V2500-A1/A5/D5 SERIES PROPULSION SYSTEMS SERVICE BULLETIN

This document transmits Revision 1 to Service Bulletin EV2500-75-0096 and Revision 1 to the Supplement

V2500-ENG-75-0096

AIR – ACTIVE CLEARANCE CONTROL (ACC) ACTUATOR – INTRODUCTION OF AN ACC ACTUATOR WITH
A REVISED SERVO VALVE

V2500-A1 ACC Actuator Family Tree
Fig.1 (Sheet 1 of 3)

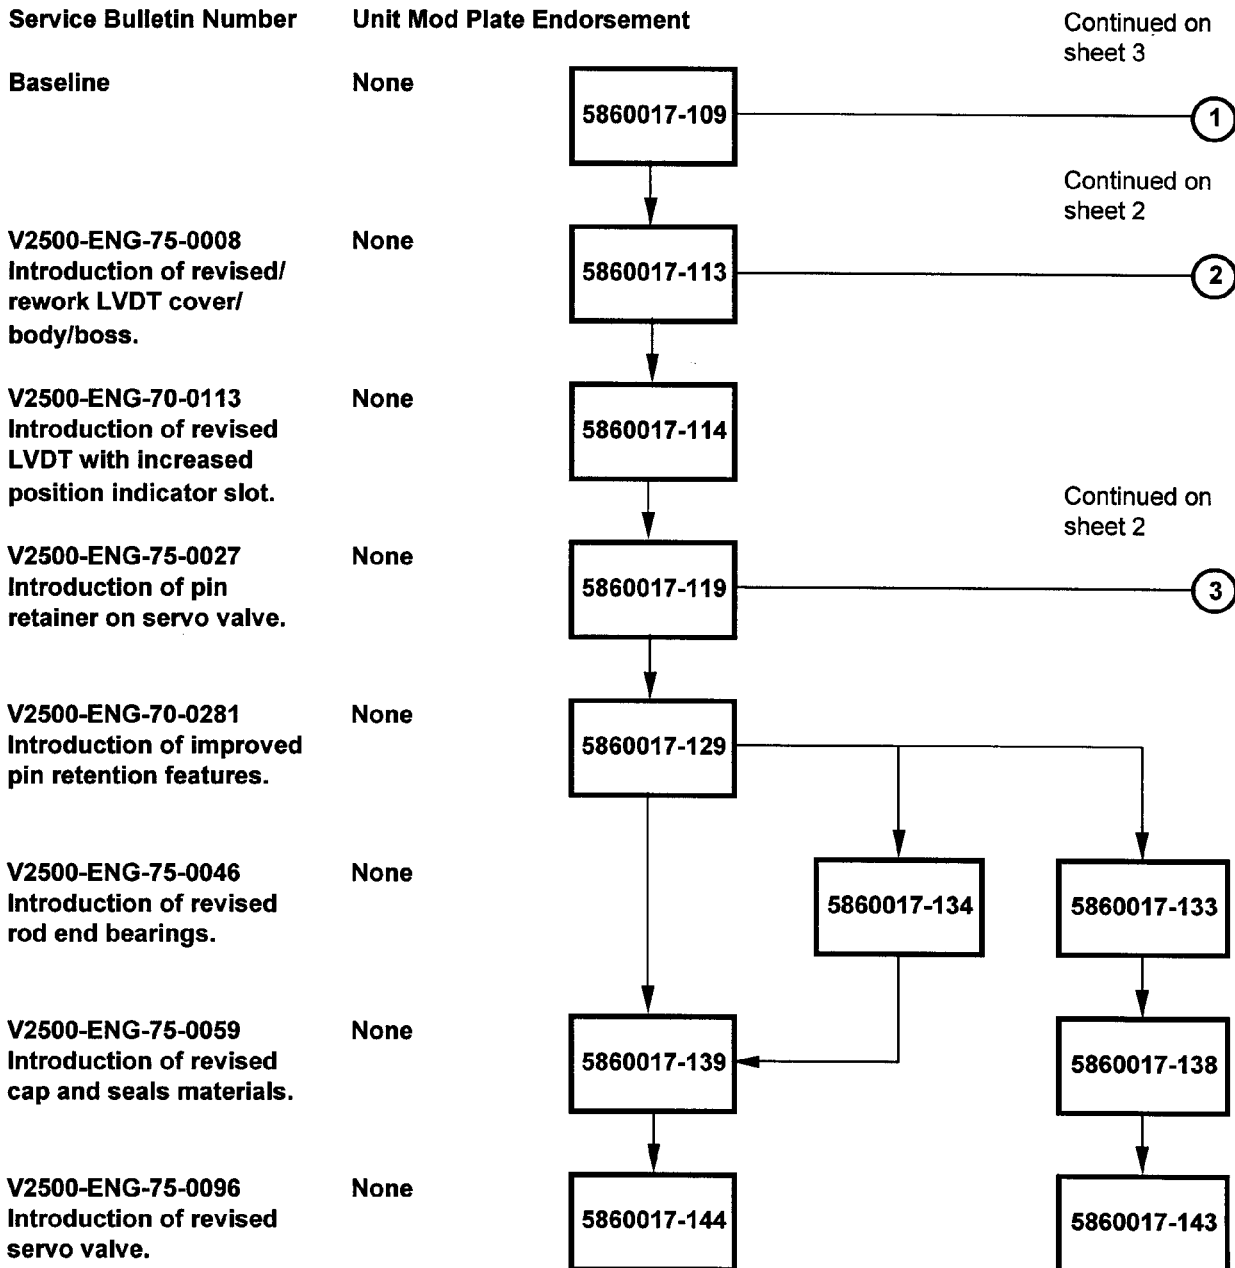
- (a) A revised ACC actuator is introduced similar to the existing unit except for the introduction of a redesigned EHSV with the following changes incorporated:
- (i) A larger cross-section 'O' ring seal and a wider groove have been introduced to prevent fuel leakage past the sleeve.
 - (ii) A redesigned end cap has been introduced changing from a one piece item to a two piece design consisting of a screwed end cap, seal carrier and also incorporating larger seals and standard seal grooves.

Install the new or reworked ACC actuator (75-24-52, 01-100), P/N 5860017-140, P/N 5860017-141, P/N 5860017-142, P/N 5860017-143 or P/N 5860017-144.

NOTE: P/N 5860017-135 can only be replaced by P/N 5860017-140.

NOTE: P/N 5860017-136 can only be replaced by P/N 5860017-141.

NOTE: P/N 5860017-137 can only be replaced by P/N 5860017-142.

NOTE: P/N 5860017-138 can only be replaced by P/N 5860017-143.

NOTE: P/N 5860017-139 can only be replaced by P/N 5860017-144.

5860017 Family Tree
Figure 1

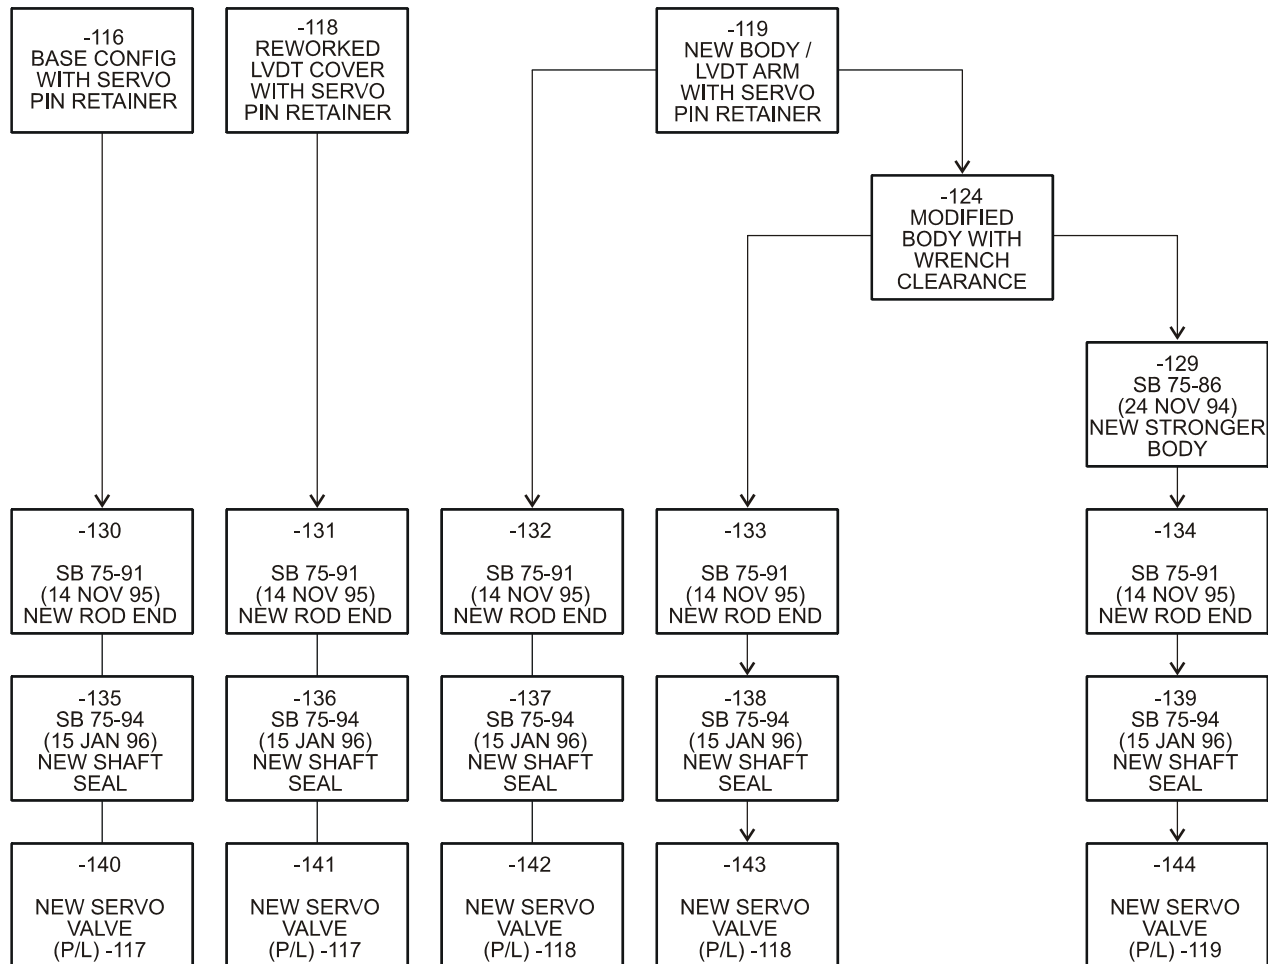
Page 4 of 6	Paragraph 2. C. (1) and (2)	Adds new steps (1) and (2) and rennumbers step (1) to (3)
Page 5 of 6	Paragraph 3. A. (4) (b)	Updates entire step (b)
Page 6 of 6	Figure 1	Adds P/L to Figure 1

NOTE: THIS FAMILY TREE INCLUDES ONLY THE ACTIVE CONFIGURATIONS OF BASIC PART NUMBER 5860017 THAT CAN BE UPGRADED WITH THE NEW SERVO. CONFIGURATIONS NOT LISTED MUST INCORPORATE THE APPROPRIATE IMPROVEMENTS THAT CONFORM TO THE CONFIGURATIONS SHOWN.

After the ACCOMPLISHMENT INSTRUCTIONS in Paragraph 3 are complete, the ACC Actuator will be identified as 5860017-140 thru 144 respectively.

Family Tree for Part Number 5910479 Configurations, Figure 1

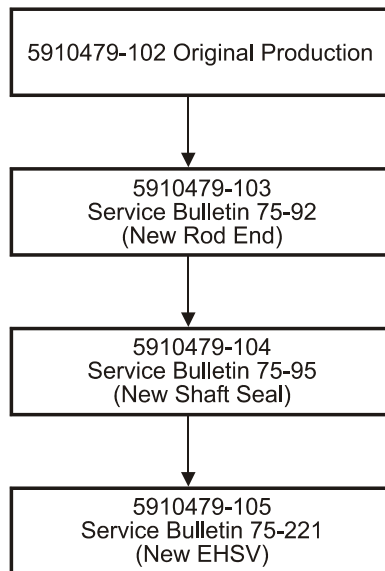
This service bulletin is issued to introduce part number 5910479-105 as a design improvement to reduce external leakage at the electro hydraulic servo valve (EHSV) by incorporating an improved EHSV, P/N 5863057-102.

After the ACCOMPLISHMENT INSTRUCTIONS in Paragraph 3 are complete, the ACC Actuator, 5910479-102, -103, or -104 configuration, will be identified as a 5910479-105 configuration.
